September Director Questions - Siegfried

Map of Pescadero Sewer location with Respect to 100 Foot Buffer from Creek

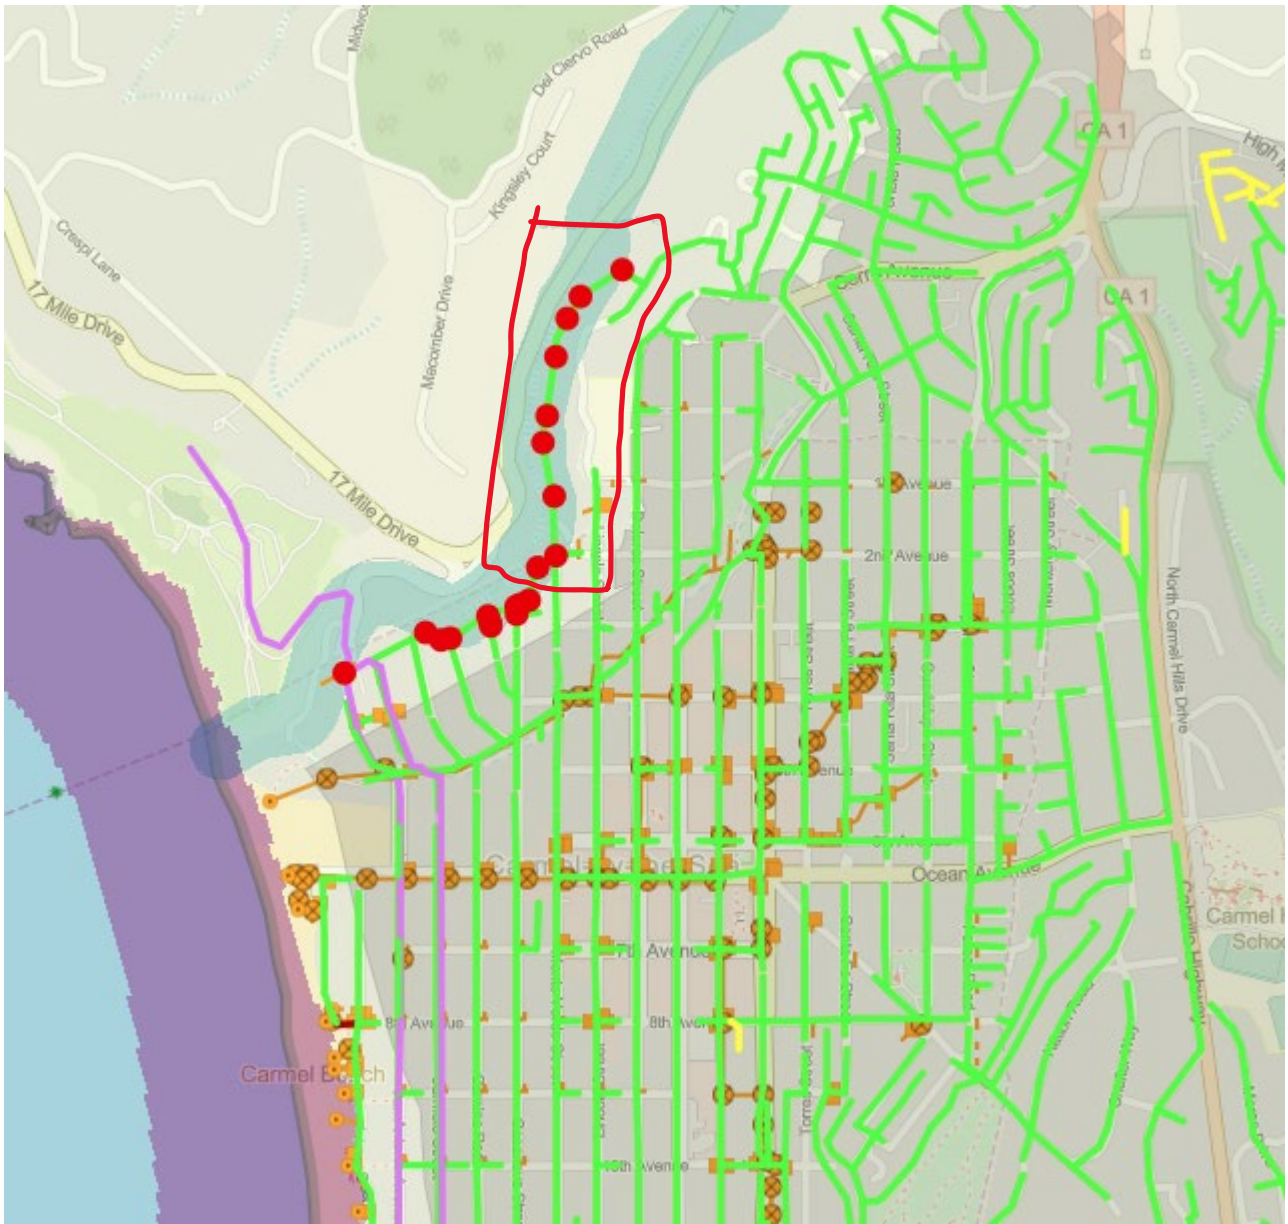
p. 347: What rating does this line have in our CIP program, and where is it in the replacement queue?

The Pescadero pipeline is rated as an overall PACP Score of 5 due to multiple cracks, offset joints and fractures. In addition, the brick manholes were rated fair to poor in the project area. The project is within 100 feet of Pescadero Creek and is required to be replaced per our agreement with River Watch (see map).

The type of damage to the pipe is not conducive with the use of pipe bursting or lining since there are offset joints, sags and breaks throughout the 100 year old clay pipe. Replacing the pipeline in its current location on a steep slope and within a narrow access path could cause slope instability due to the need to use open trench construction to replace the pipe in place. Even if pipe bursting could be used, this requires the excavation of access pits and other pits to connect laterals to the line. The pipe trenches in either case will need to be between 5 feet to 8 feet deep. It is highly unlikely that permits could be obtained for replacement of the pipeline in its current location due to environmental concerns and slope stability issues.

Currently, our equipment cannot access the pipeline for maintenance or to respond to a spill. This pipeline has had 5 overflows in the past 8 years, with one of them in 2021. Over 200 homes direct their sewage to the pipeline with a peak rate of flow of about 400 gallons per minute. Directing the flow to Pescadero Road will eliminate the risk of spilling sewage into the waterway.

The project is the third item on our Capital Improvement Project list for Collections.
